SUBJECT: EMERGENCY TECHNICAL SPECIFICATION CHANGE, REACTOR COOLANT SYSTEM  
FLOW MEASUREMENT UNCERTAINTIES (TAC NO. 69804)

RE: SALEM GENERATING STATION, UNIT NO. 2

Amendment No. 64  
License No. DPR-75

SAFETY EVALUATION BY THE OFFICE OF NUCLEAR REACTOR REGULATION  
SUPPORTING AMENDMENT NO. 64 TO FACILITY OPERATING LICENSE NO. DRP-75

Figure 3.2-3  
RCS TOTAL FLOWRATE VERSUS R - FOUR LOOPS  
IN OPERATION

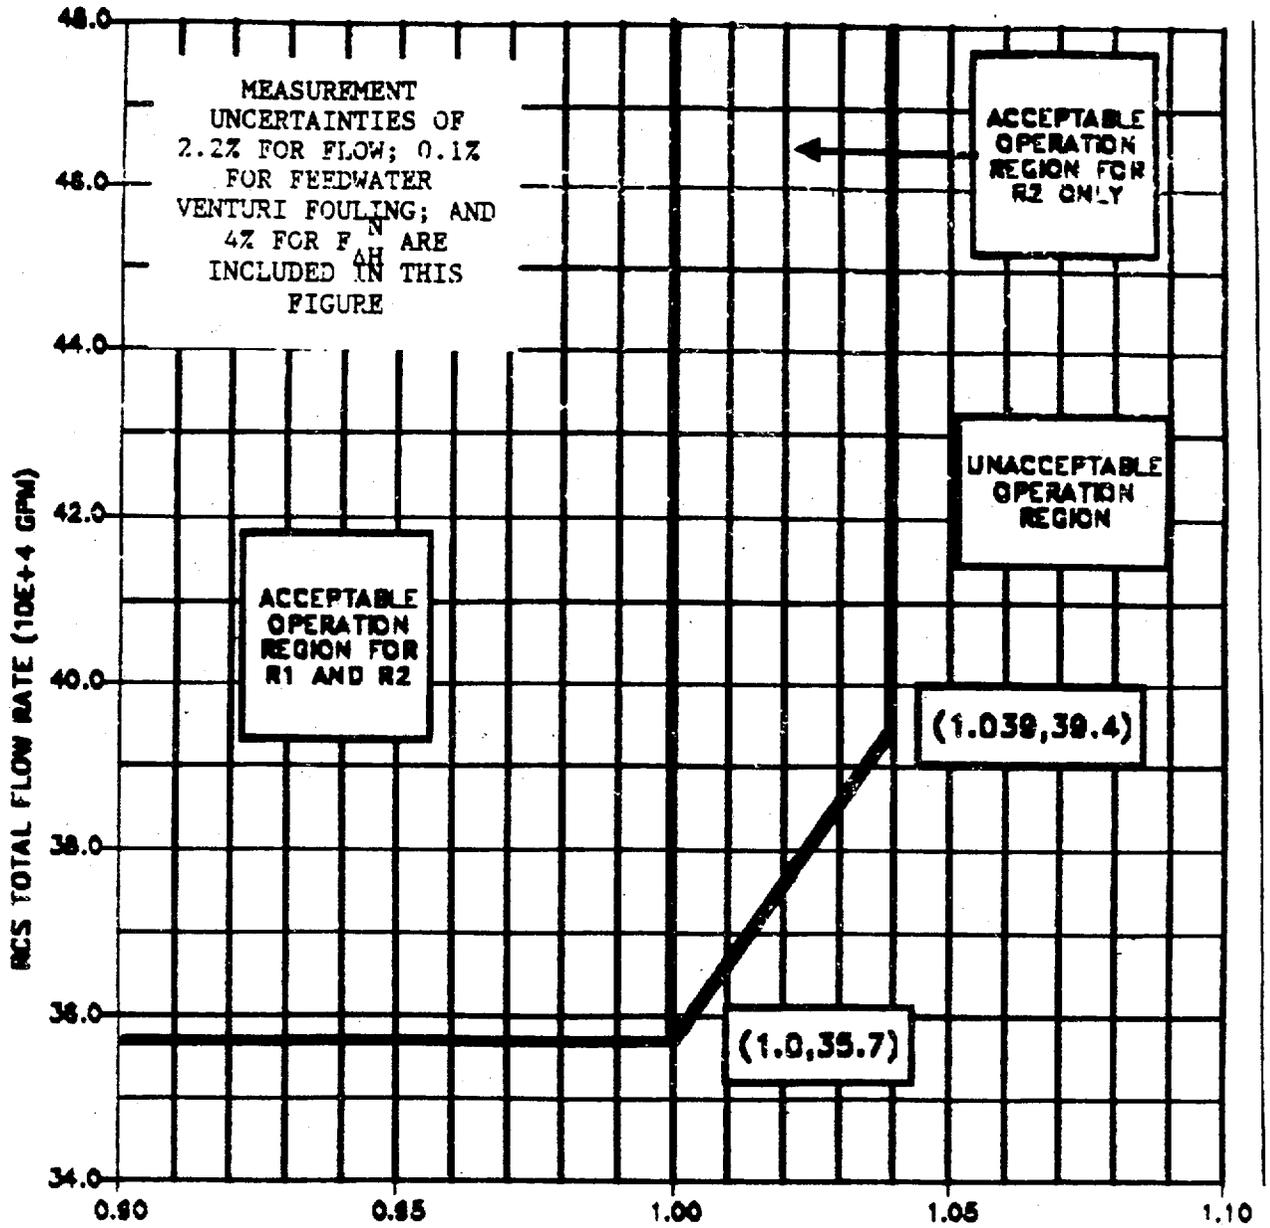
This amendment consists of a change to the Technical Specifications to reduce the correction for flow measurement uncertainty from 3.5% to 2.2%.

d.  $F_{\Delta H}^N$  = Measured values of  $F_{\Delta H}^N$  obtained by using the movable incore detectors to obtain a power distribution map. The measured values of  $F_{\Delta H}^N$  shall be used to calculate R since Figure 3.2-3 includes penalties for undetected feedwater venturi fouling of 0.1% and for measurement uncertainties of 2.2% for flow and 4% for incore measurement of  $F_{\Delta H}^N$ .

The licensee does not intend to revise the value of thermal design flow used in the DNRR analysis. The requested change is only being applied to Figure 3.2-3 and the resultant value of minimum allowable RCE flow. The net result of the requested change is to redefine the reference point but maintain the magnitude of the existing margin of safety.

When RCS flow rate and  $F_{\Delta H}^N$  are measured, no additional allowances are necessary prior to comparison with the limits of Figure 3.2-3. Measurement errors of 2.2% for Reactor Coolant System total flow rate, 0.1% for feedwater venturi fouling, and 4% for  $F_{\Delta H}^N$  have been allowed for in the determination of the design DNBR value.
